June 30, 2001
Project A51-01.02

Re: Addendum to Work Plan, Alaska Gasoline Company, Oakland, California

FIGURE 4 - PROPOSED WELLS

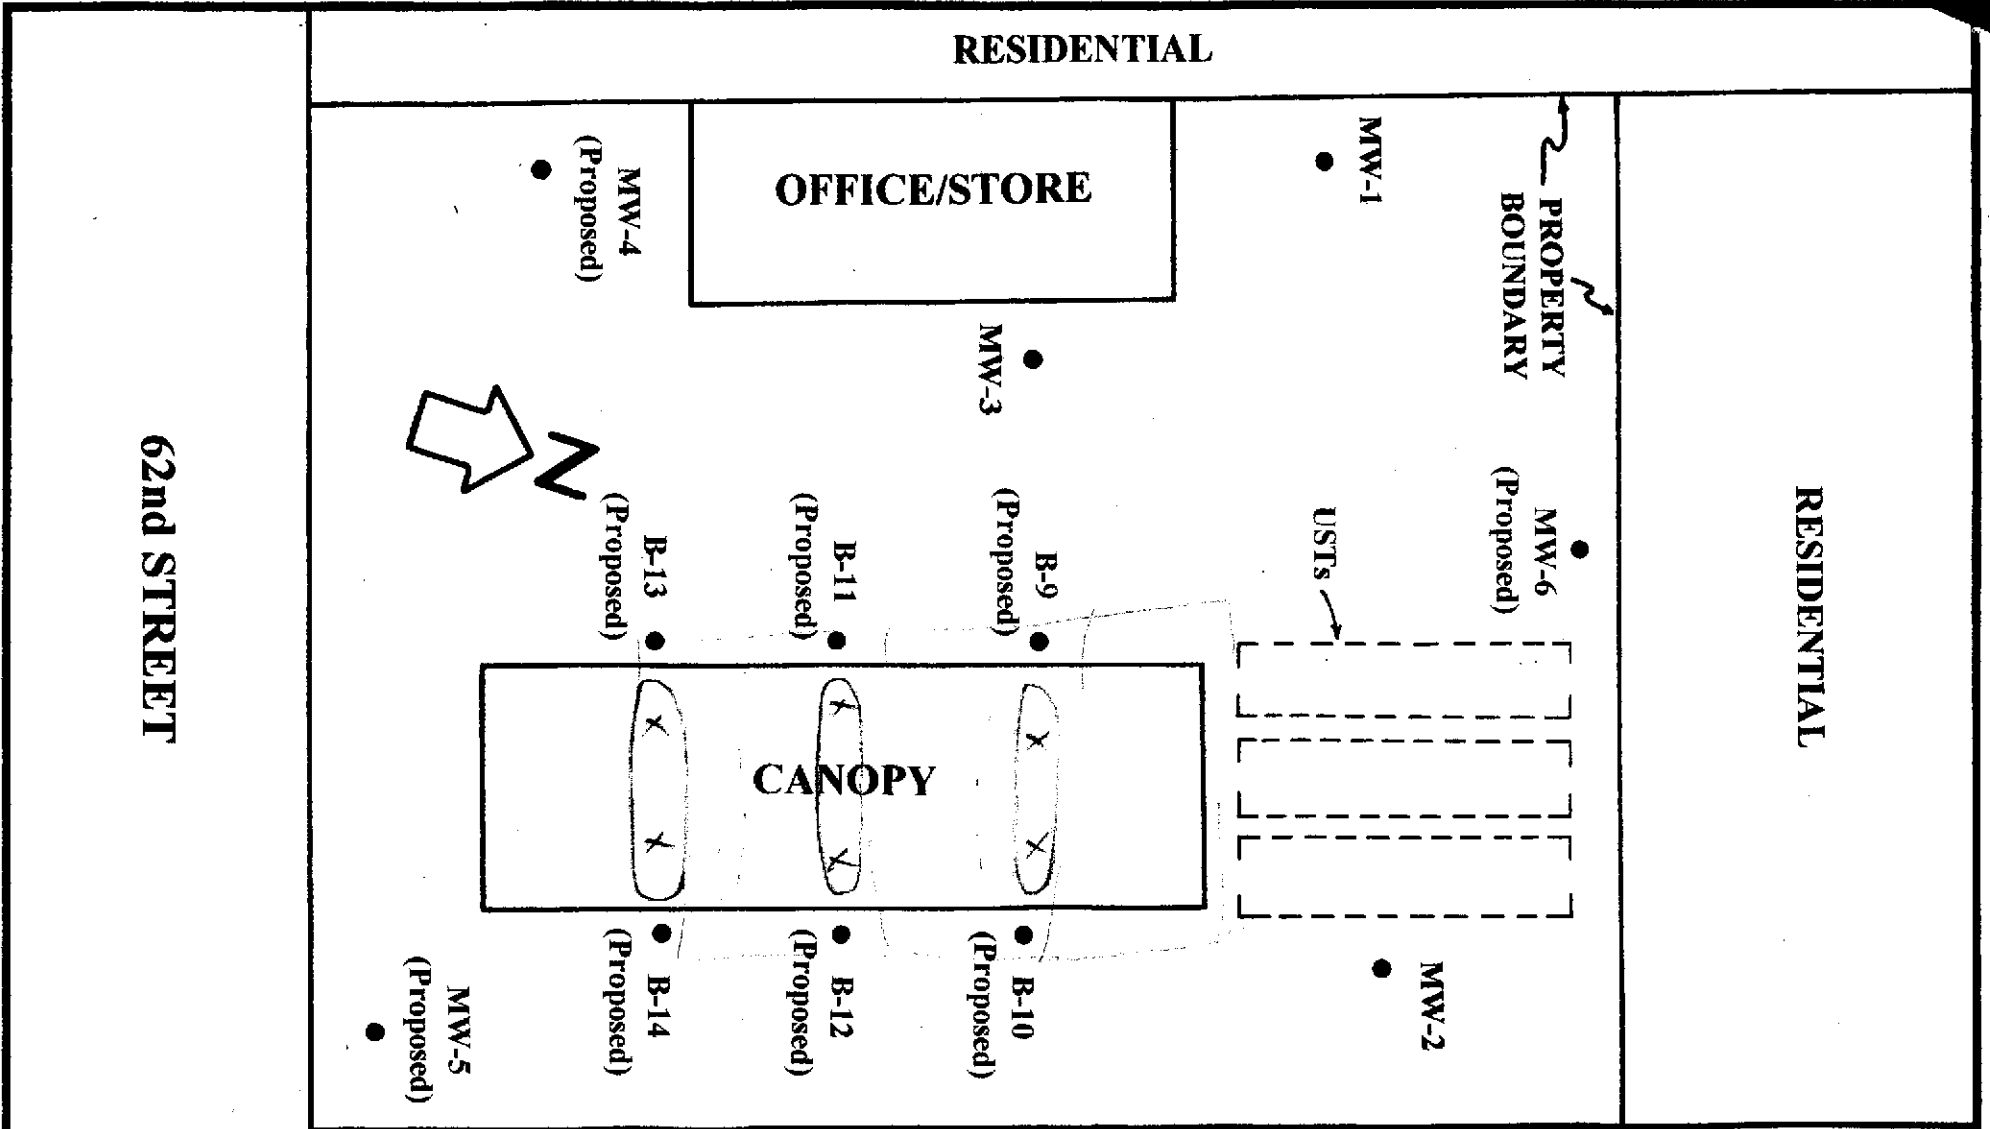
As discussed, your office has approved the proposed work, but has requested that an additional groundwater monitoring well (MW-6) be installed near the existing underground storage tanks (USTs), and that borings be drilled and sampled near each end of each dispenser island (B-9 through B-14). The location of proposed wells and borings are presented on the attached revised Figure 4.

Monitoring well MW-6 will be drilled, sampled, and installed in a similar manner as previously proposed MW-5 and MW-6. Soil borings B-9 through B-14 will be drilled and sampled with the same equipment and in a similar manner as the proposed monitoring wells. Soil samples will be collected from five and ten feet from each of the borings. Groundwater was present at an approximate depth of 5.86 feet on March 8, 2001, and is known to have been as deep as approximately 8.11 feet in November, 1999. Soil samples will be collected and handled in a similar manner as previously described for soil sampling from the proposed monitoring wells. Laboratory analysis will be identical as previously proposed.
